# 66105A-08A

# S E R V I C E N O T E

## 66105A DC Power Supply

**The instrument will not communicate or will not complete self test.**

**FIGURE 1** Is the Tested PCA P/N 66101-61022 note (Location of Circuit Reference "U2")

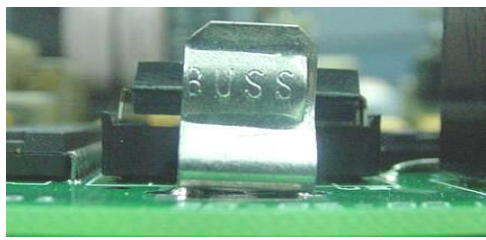
The Programmed ROM P/N 5080-2529 (Circuit Reference "U2") See Figure 1.below for the location of "U2". The Programmed ROM Shows "U2" can be inspected with out taking the entire instrument apart see figure 2 below. Inspect the ROM "U2" as described in Diagrams "A & B" below.

When the ROM "U2" is not inserted correctly See Diagram "A" for details, the instrument may exhibit the following faults:

The ROM "U2" should be removed from the socket. (See Figure 1). The socket and the ROM should be inspected for contamination or other defects. The ROM is a ceramic part and can be damaged or broken if too much force is applied when reinstalled. Diagram "B" shows the ROM "U2" inserted correctly.
